Topock Soil RFI/RI – Plan to Address Data Gaps Identified During Work Plan Implementation (DG-WP-01)

DOCUMENT ID: PGE20160113A
PREPARED FOR: Pacific Gas and Electric Company (PG&E)
PREPARED BY: CH2M
DATE: January 13, 2016

FIGURE C7-7
Proposed Phase 2
Soil Sample Locations
AOC 14 - Railroad Debris Site

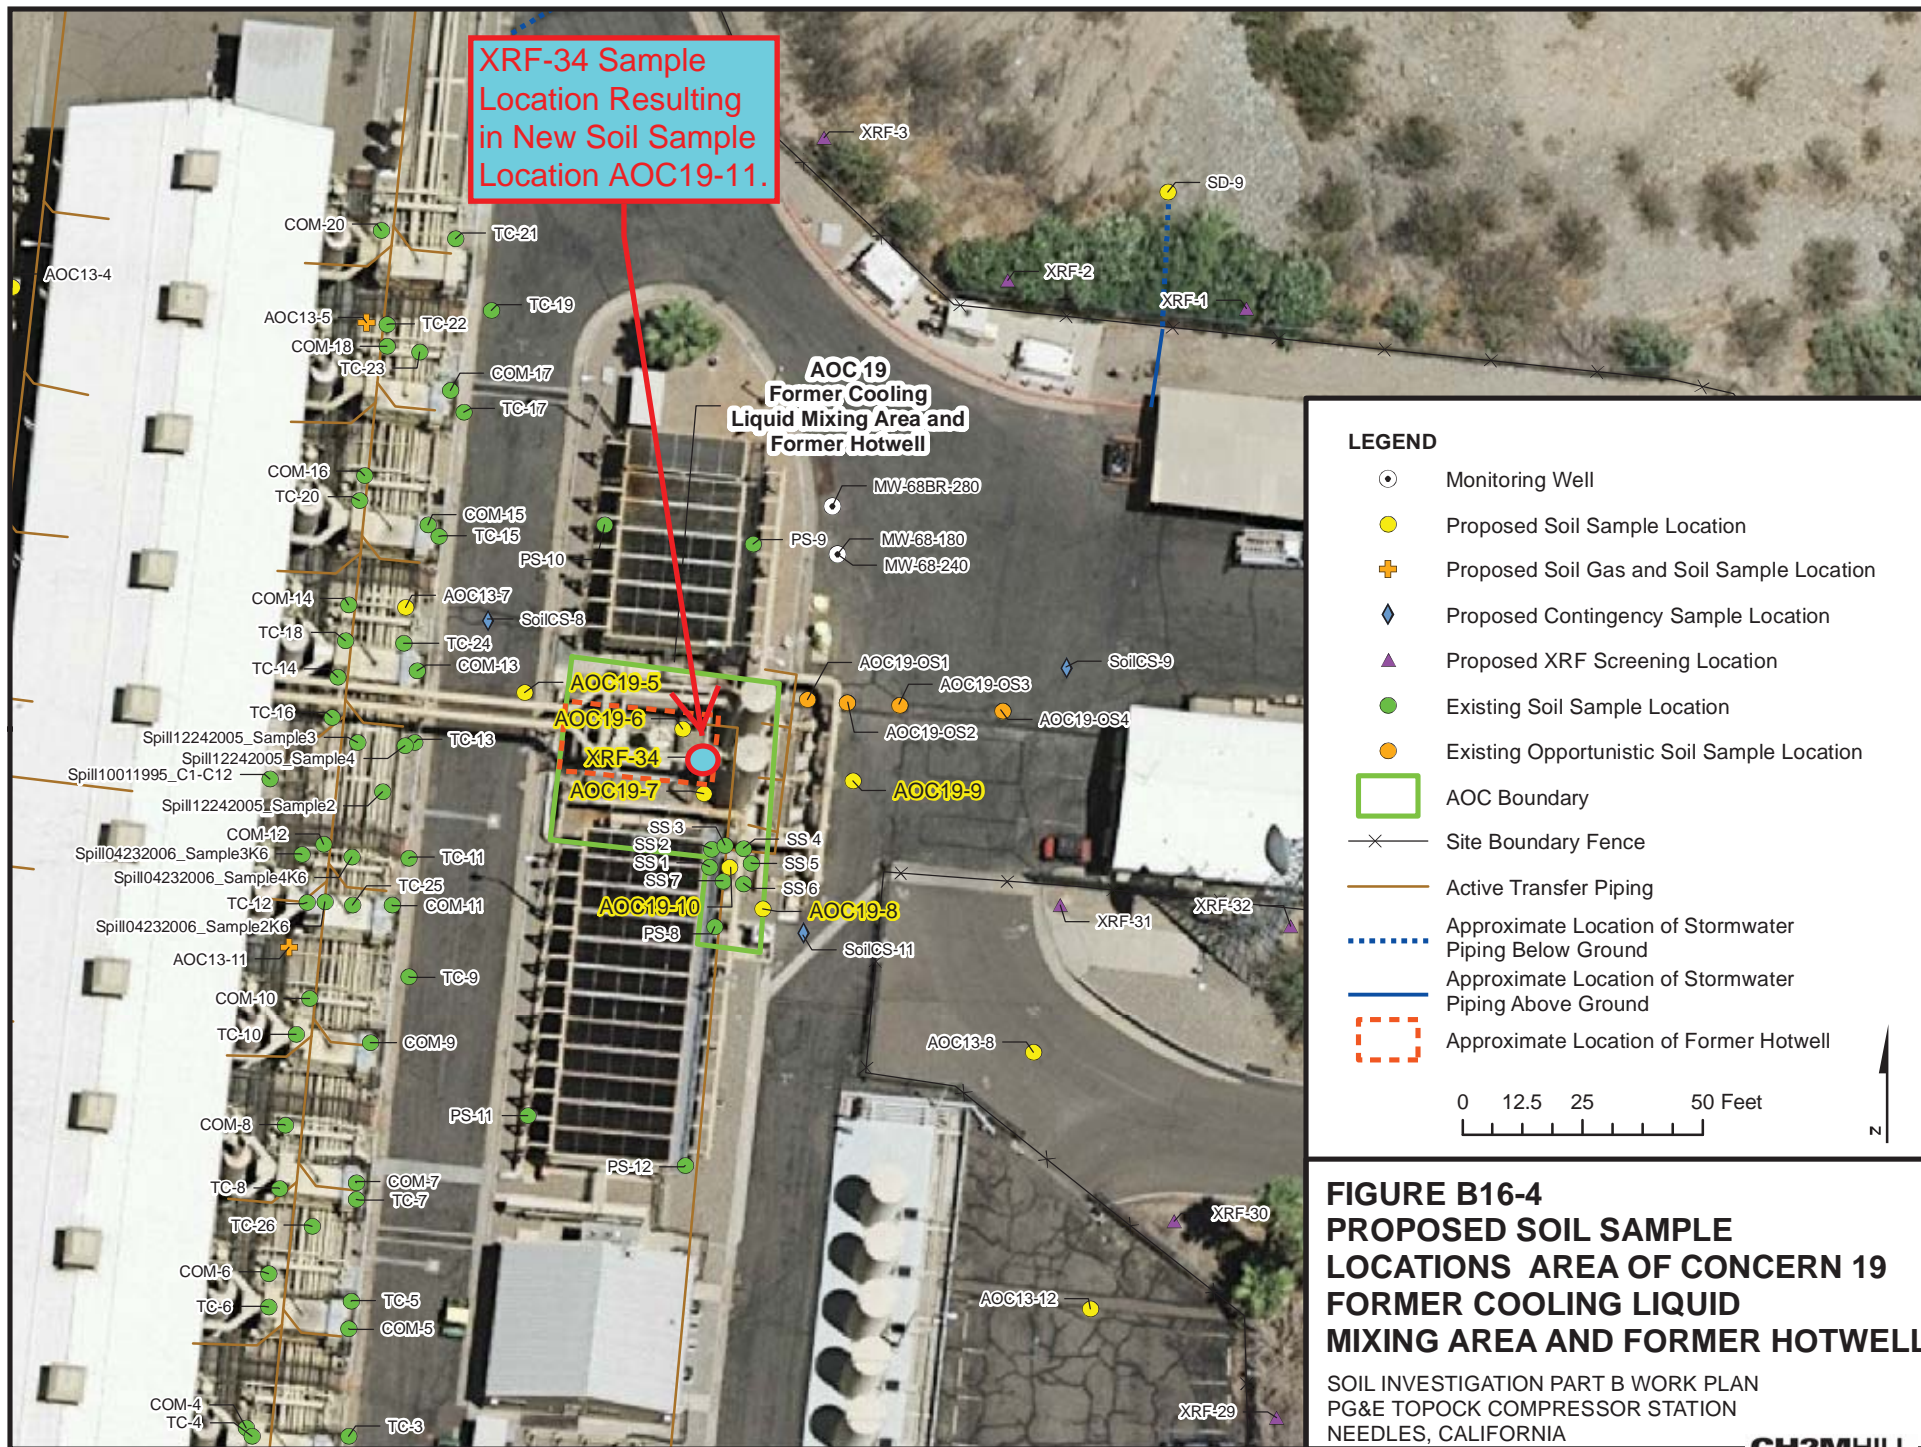
Two additional sample locations are included in this plan to address data gaps (annotated Work Plan Figure C7-7.)

Additional Location ID	Depths (ft bgs)	Description/Rationale	Analytes	Anticipated Collection Method
AOC14-18	0, 2, 5 and 9 (as feasible)	Added based on the results of XRF analysis of a surface soil sample collected at location XRF-07 (elevated concentrations of nickel and copper). Data collected at this location will be used to resolve Data Gap #2, - assess lateral and vertical extent of contamination due to debris east of AOC 14.	Hexavalent chromium Title 22 metals	Hand tools
AOC14-19	Debris and directly beneath.	Added based on the observation of debris in the road cut. The observed debris and soil directly beneath the debris will be sampled from the road cut side wall at this location. Data collected at this location will be used to resolve Data Gap #2 – assess the additionally identified potential burn area west of AOC 14.	Hexavalent chromium, Title 22 metals, PAHs, TPH, SVOCs, PCBs, Pesticides, pH, Dioxins and furans	Hand Tools

The objective of data collection for locations AOC14-14 through AOC14-17 has been reviewed with the agencies, and as a result, the approach to sample collection at these locations has been modified from roto sonic to backhoe. While this approach to sample collection is consistent with the potential methods identified in the Work Plan, it is different than what has been discussed with the Tribes in the field to date. As initially planned these locations would be sampled using a roto sonic drill rig that would access the work area from the Interstate 40 freeway using a crane; however, after further discussion with the agencies, it was determined that the use of a backhoe to collect these samples would yield better data than core from a drilled boring and help minimize the potential for data gaps. This approach will also provide a safer work environment for the field crew since the freeway will not need to be controlled for equipment access (the backhoe will access the site from the north, across the railroad tracks). The Work Plan specifies that samples should be collected at each of these locations to a depth of 14 feet. It is acknowledged that a backhoe may not be able to achieve this depth, but that it is appropriate to sacrifice the depth of sample collection for the ability to see trench sections and assess the extent of potentially buried debris. This work will be conducted from south to north and the extent of buried debris visible in the side wall (due south of AOC14-14 at additional location AOC14-19) will be used to guide the eastern extent of the trenches if no buried debris are observed. As debris is encountered in the trenches, samples of the debris (i.e. unconsolidated, visually impacted material) and immediately below the debris will be collected in addition to the sample depths included in the work plan. The trenches will be installed to the depth feasible using a backhoe. Material that is removed from the trenches will be replaced into the trench from which it was removed; however, to the extent practicable, debris or visually impacted material that is removed from the trenches will be contained and characterized for disposal in accordance with the Work Plan.

FIGURE C11-2
Proposed Phase 2
Soil Sample Locations
AOC 27 - MW-24 Bench
Soil Investigation Part A
Phase 1 Data Gaps Evaluation Report
Pacific Gas and Electric Company Topock Compressor Station
Needles, California

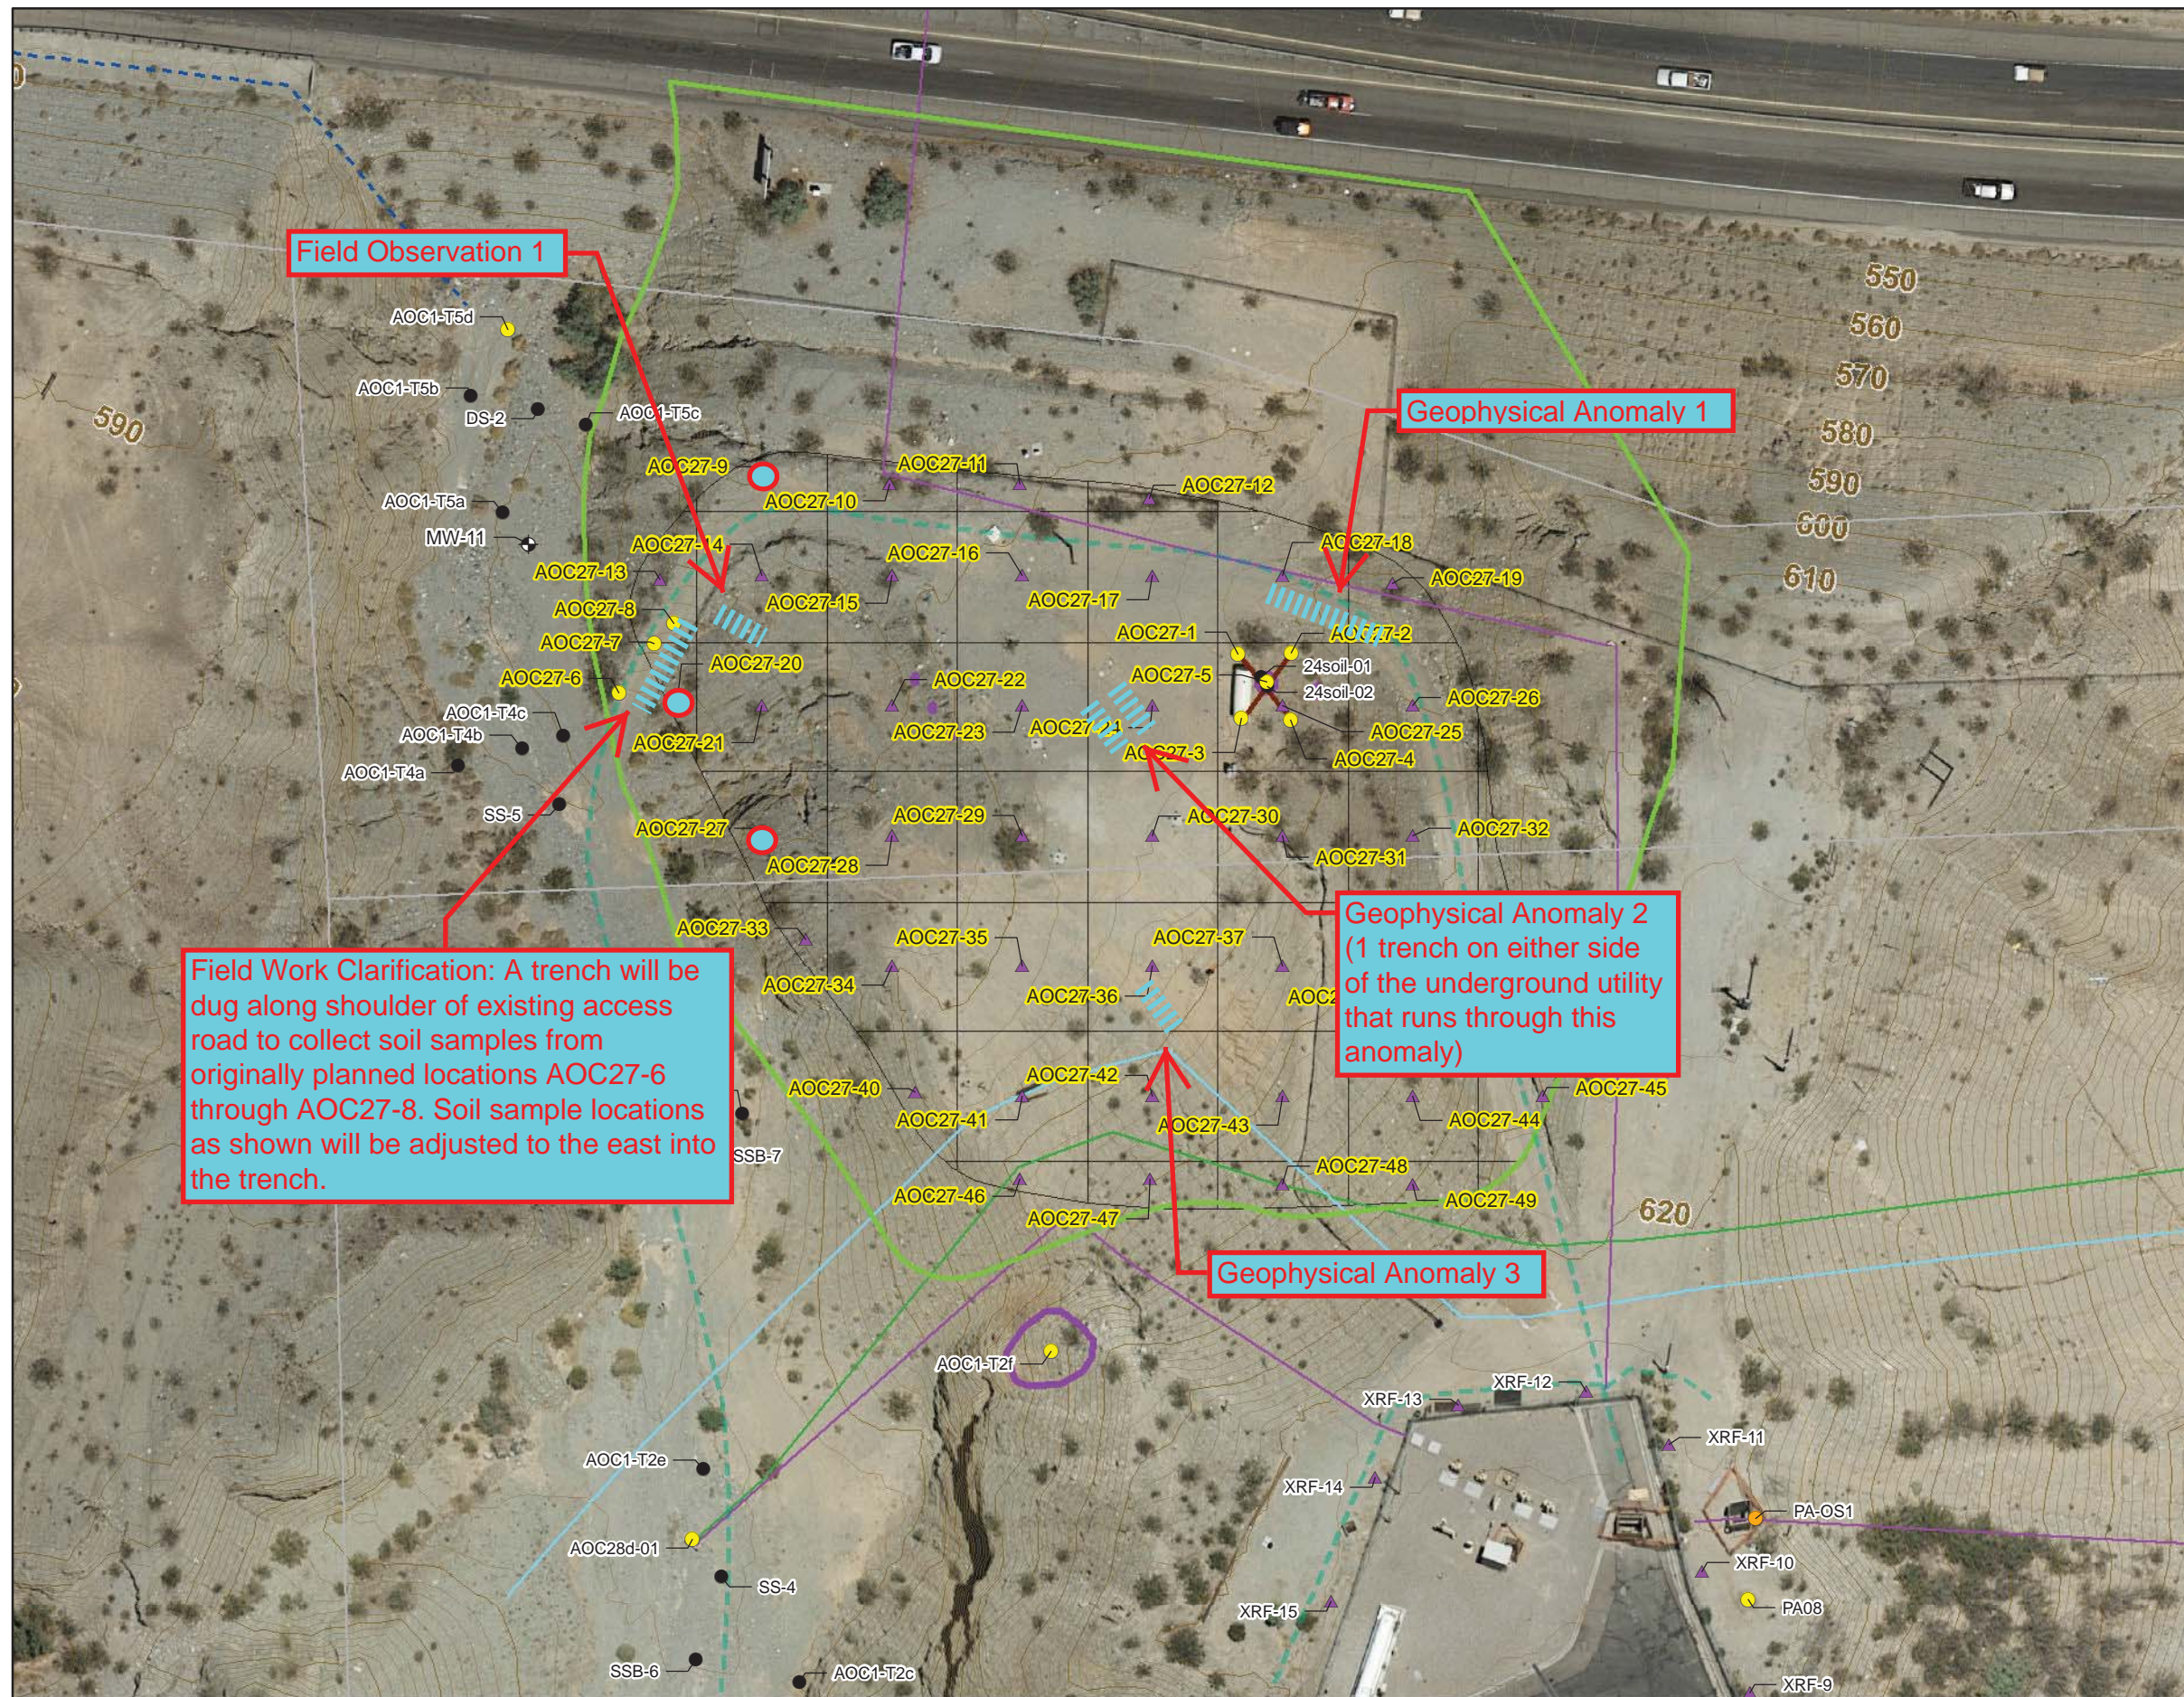
Three additional sample collection locations are included in this plan to address data gaps (annotated Work Plan Figure C11-2). In addition, a new area of debris that was observed during work plan implementation will be investigated by trenching/potholing. Three geophysical anomalies were identified during the geophysical survey and will also be investigated by trenching/potholing. Samples within the trenches/potholes will be collected from debris that is encountered (i.e. unconsolidated, visually impacted material) and immediately below the debris at three locations (one location at each end, and one in the middle).

Additional Location ID	Depths (ft bgs)	Description/Rationale	Analytes	Anticipated Collection Method
AOC27-9	0, 2, 5 and 9 (as feasible)	Added based on the results of XRF analysis of a surface soil sample collected at location AOC27-9. Data collected at this location will be used to resolve Data Gap #1 – Nature and extent of contamination in the additionally identified debris area in the MW-24 bench area.	Hexavalent chromium, Title 22 metals, PAHs, TPH, VOCs (excluding surface sample), SVOCs, PCBs, Pesticides, pH, Dioxins and furans (where debris/soil is dark in appearance or appears burned only)	Rotosonic
AOC27-20	0, 2, 5 and 9 (as feasible)	Added based on the results of XRF analysis of a surface soil sample collected at location AOC27-20. Data collected at this location will be used to resolve Data Gap #1 – Nature and extent of contamination in the additionally identified debris area in the MW-24 bench area.	Same as AOC27-9	Backhoe

AOC27-27	0, 2, 5 and 9 (as feasible)	Added based on the results of XRF analysis of a surface soil sample collected at location AOC27-27. Data collected at this location will be used to resolve Data Gap #1 – Nature and extent of contamination in the additionally identified debris area in the MW-24 bench area.	Same as AOC27-9	Rotosonic
Field Observation 1	Bottom of trench, and if debris is encountered, within and beneath the debris	Added based on field observation of an area of potentially burned debris contained in a soil pile. Data collected at this location will be used to resolve Data Gaps #1 and #2 – Nature and extent of contamination in the additionally identified debris area in the MW-24 bench area and nature and extent of debris.	Same as AOC27-9	Backhoe
Geophysical Anomaly 1	Bottom of trench, and if debris is encountered, within and beneath the debris	Added based on subsurface geophysical anomaly. Data collected at this location will be used to resolve Data Gaps #1 and #2 – Nature and extent of contamination in the additionally identified debris area in the MW-24 bench area and nature and extent of debris.	Same as AOC27-9	Backhoe

Geophysical Anomaly 2	Bottom of trench, and if debris is encountered, within and beneath the debris	Added based on subsurface geophysical anomaly. The area of this anomaly is interrupted by a subsurface utility; therefore, a trench on either side of the utility is required. Data collected at this location will be used to resolve Data Gaps #1 and #2 – Nature and extent of contamination in the additionally identified debris area in	Same as AOC27-9	Backhoe

the MW-24 bench area and nature and extent of debris.		
Geophysical Anomaly 3	Bottom of trench, and if debris is encountered, within and beneath the debris	Added based on subsurface geophysical anomaly. Data collected at this location will be used to resolve Data Gaps #1 and #2 – Nature and extent of contamination in the additionally identified debris area in the MW-24 bench area and nature and extent of debris.	Same as AOC27-9	Backhoe

A change in AOC 27 site conditions since the Work Plan was finalized has been reviewed with the agencies, and as a result, the approach to sample collection for locations AOC27-6 through AOC27-8 has been modified from hand tools to a trench using a backhoe. While this approach to sample collection is consistent with the potential methods identified in the Work Plan, it is different than what has been discussed with the Tribes in the field to date. At the time of work plan development, the locations were previously located in an eroded drainage channel on the east side of the access road, but that channel is now filled due to road maintenance conducted after the Work Plan was finalized. Based on site observation and review of a photograph previously taken by DTSC, the general area was confirmed and it was determined that instead of collecting three discrete surface samples, PG&E should install a shallow trench (3 feet deep, or less) to expose the debris that had been recently covered by road maintenance. Samples will be collected from the debris (i.e. unconsolidated, visually impacted material) and immediately below the debris at three locations within the trench (one location at each end, and one in the middle). Material that is removed from the trenches will be replaced into the trench from which it was removed; however, to the extent practicable, debris or visually impacted material that is removed from the trenches will be contained and characterized for disposal in accordance with the Work Plan.
